Re: Response to October 17, 2014 Letter to Amenia Planning Board
Silo Ridge Resort Community
Amenia, NY

On behalf of our client, Silo Ridge Ventures, LLC. (the "Applicant"), VHB Engineering, Surveying and Landscape Architecture, P.C. (VHB) offers the following responses to your GML § 239-l/m review memorandum dated October 17, 2014 regarding Referral 14-340, Silo Ridge Resort Community Special Use Permit and Phase 1 Site Plan. Your comments have been numbered and directly below each comment is the response¹.

Diagram 1: Cross Section Example of Existing Trees at Estate Road

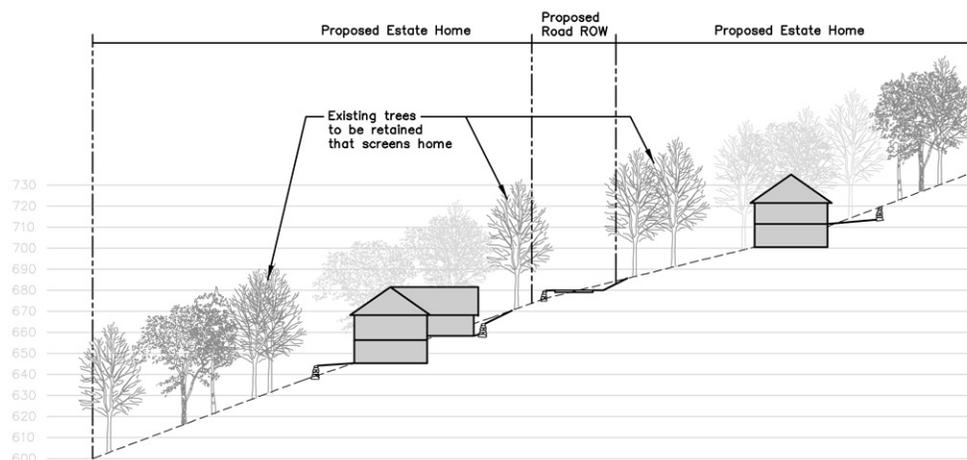
3. In addition to increasing the number of new trees around the homes, we recommend some larger specimen trees, possibly from elsewhere on the properties, be relocated to these screening areas. This will create a more immediate screening effect and will provide baseline vegetation for new 3"-4" caliper specimens to fill in. Without a basic fabric of more mature trees, it will likely take 10-20 years for the new plantings to reach maturity and provide screening.

Response DCP-3: All plans have been revised to show clearing only within the designated ADA for each Estate Home lot, with the exception of certain driveways and sewer lines. Additionally, as stated in "Appendix K: Design Standards for Estate Homes" of the Amended MDP: one (1) shaded tree shall be planted per 1,000 square feet of the home floor area proposed to be developed on the lot, except that for every one (1) existing shade tree 8 inches DBH or greater within the ADA preserved by the lot owner, one (1) less new shade tree shall be required.

Furthermore, the project has been designed to minimize visual impacts by using existing topography and minimizing disturbance to existing vegetation, including mature trees. For example:

The site for the Estate Home area along Ridgeline Road and Oak Tree Lane is currently vegetated with existing mature trees. These trees naturally vary in height but are generally in the range of 60 to 80 feet tall. In planning this area, the intent is to maintain horizontal swaths of existing trees in order to provide a veil for the homes that would be located upslope of the existing trees. The goal of this strategy is to maintain the appearance of continuous tree cover so that there is no significant adverse change from the existing condition (See diagram 1 below).
